MEMORANDUM

RE: Intersection @ Park Ave and Route 2's Frontage Roads

Dear Arlington Selectboard,

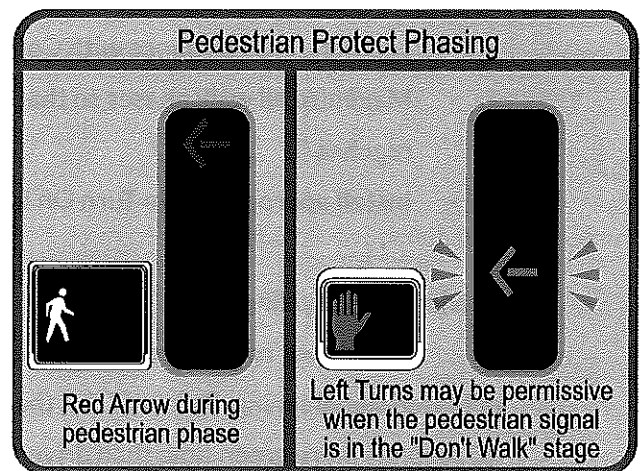
Maintenance at these signals is also infrequent. Concord Turnpike's approach on Arlington's side of the interchange has an extremely dangerous situation that could confuse a driver into thinking

they had a green light, because of a missing visor on a Park Avenue signal, as seen in the photo to the right. Furthermore, outdated "doghouse" style left turn signals currently exist at this location. MassDOT

- Perform maintenance on this signal, to check that it is up to MassDOT standards.
- Install Flashing Yellow Arrow left turn signals to replace older style 5-section signals.
  - Program a pedestrian protect phase, so that if a pedestrian clicks the crosswalk button, left turns are converted to protected only so that pedestrians can cross in a safer manner. (See image on right)
